Minerals Inspection Report

and the second			
Mine Name: Keigley Quarry		Permit Number:	M/49/0001	Mine Status:	Active
Operator Name: Staker and Parsons Company		Inspection Date:	12/05/2013	Permit Fees:	Paid
Inspector(s): April Abate		Inspection Time:	11:00 AM	Bond Amount:	\$1,402,000
Attendee(s): Bryson Hinkins, Staker Parsons		Weather:	Cold Clear 11	deg Bond Escalation:	01/01/2017
Insp	ection Purpose: Inspect the quarry to familarize my	self with the site.		Prior Inspection:	
The	clusions and Recommendations operator should work with the Division to produce yard area on the north side of the property should be			sued in the NOV of March	4, 2013. The
	Elements of In	spection		Evaluated & Commented	Enforcemen

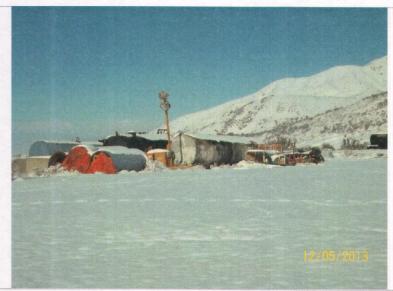
Highwall located on the north side of the site. No mining activity is presently occurring here.

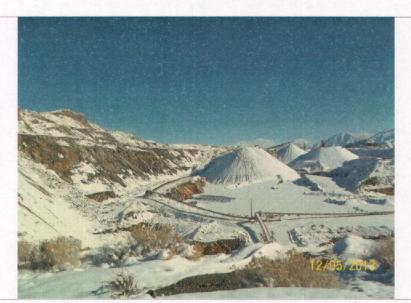
Boneyard area on the north side of the property. This reportedly belongs to an individual who was allowed to store his debris on the property.
